**DUKE ENERGY**  
**McGUIRE NUCLEAR SITE**  
**EMERGENCY PLAN**

**REVISION 17-1: September, 2017**

**MNS Emergency Plan Section F Emergency Communications Rev. 17-1**

Document and Revision  
**MNS Emergency Plan Section F, Emergency Communications, Rev. 17-1**

FIGURE F-1  
MCGUIRE NUCLEAR SITE EMERGENCY COMMUNICATIONS  
(Prior to TSC/EOF Activation)

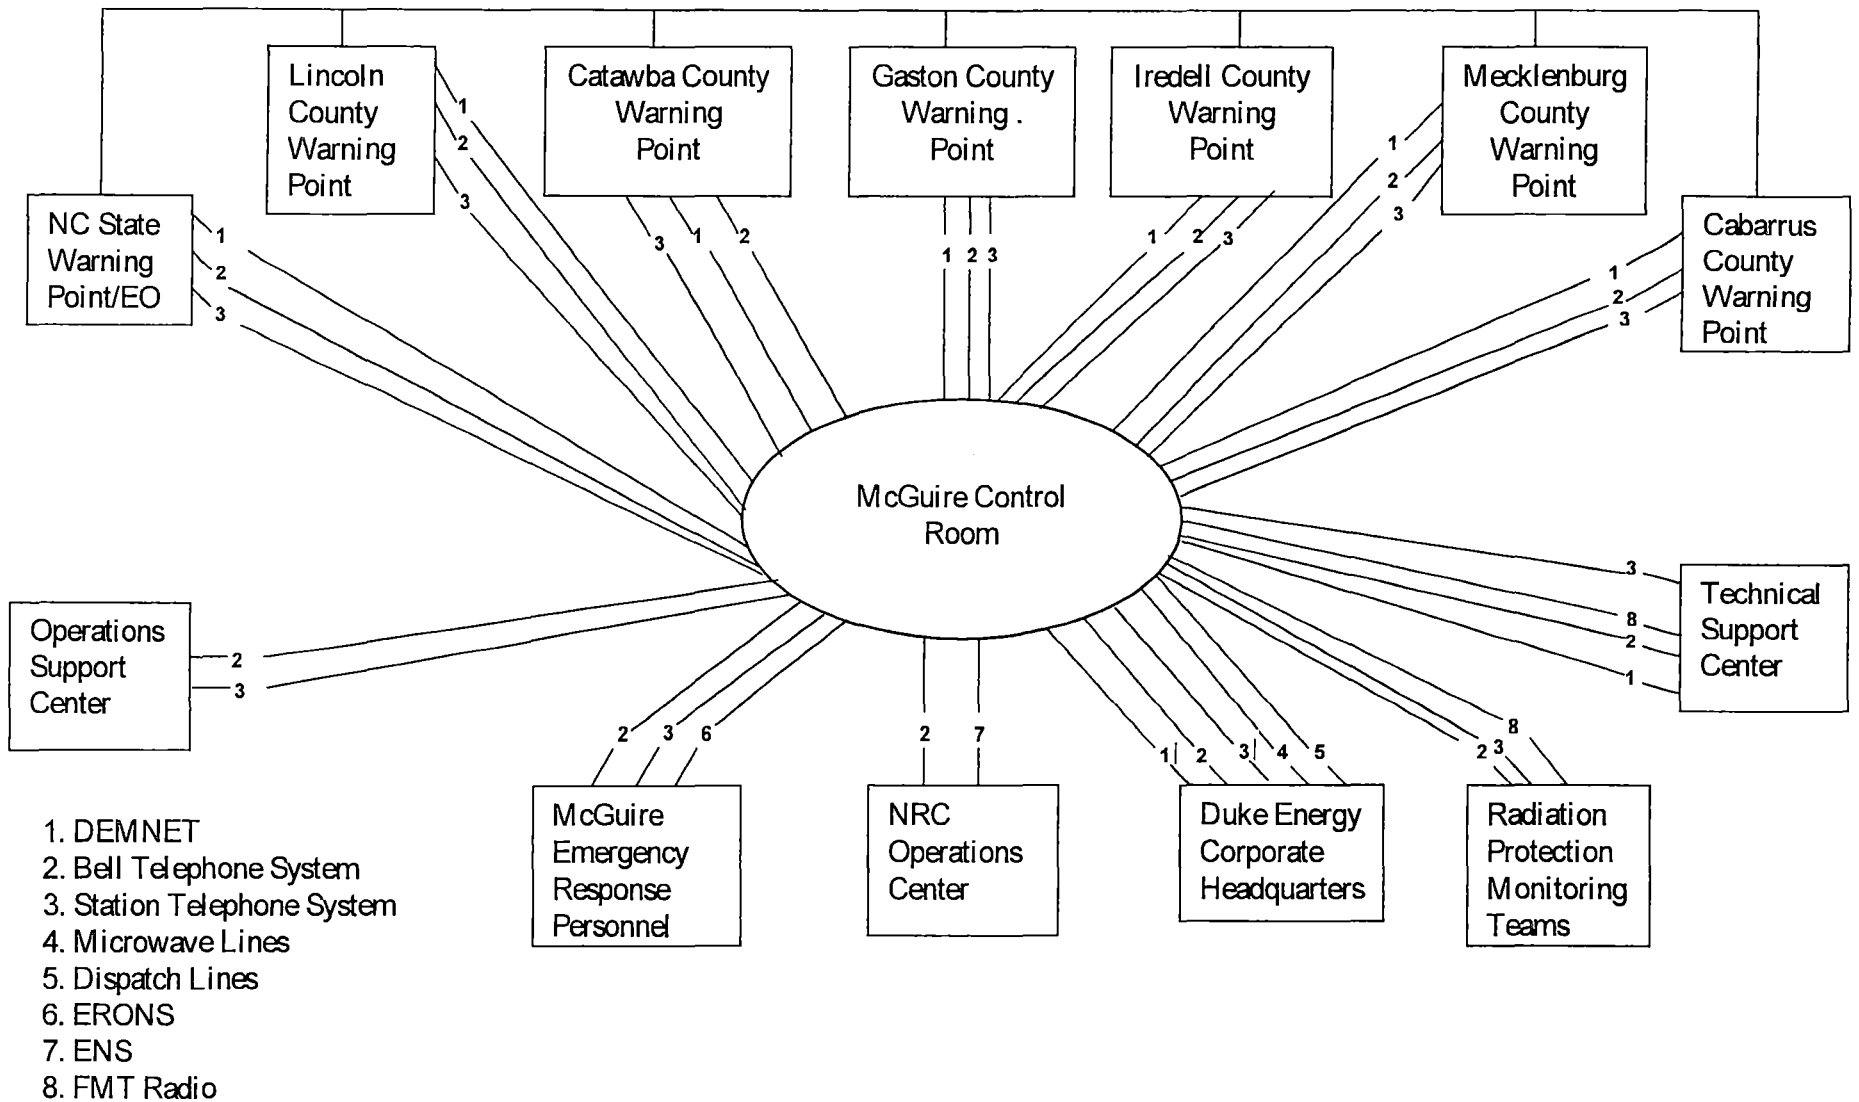
Part I. Description of Proposed Change:  
Retire 48.50 MHz radio from MNS Emergency Plan. The 48.50 MHz County Emergency Response Radio in the MNS Emergency Plan is obsolete, not functional, and due to obsolescence, parts are no longer available to repair the radio.

See also attached revised MNS Emergency Plan Figures F-1 and F-2.

Prior to this change the McGuire Emergency Plan described three means of contacting states/counties in the 10-mile EPZ. They are:

- DEMNET (Primary)
- Standard Telephone Lines (Backup)
- County Emergency Response Radio can be used to communicate between the Control Room, TSC, EOF and counties (48.50 MHz Radio).

The 48.50 MHz County Emergency Response Radio is described in the McGuire Emergency Plan as a system that can be used to communicate between the Control Room, TSC, EOF and counties. This system was installed during the 1980s and is obsolete, not functional and unreliable. Due to obsolescence parts and service are not available for this equipment as it is considered antiquated technology. As a result of this change, the radio system will be removed from the McGuire Emergency Plan and physically removed from McGuire emergency facilities as well as county warning points. This equipment has already been removed from the Emergency Operations Facility.
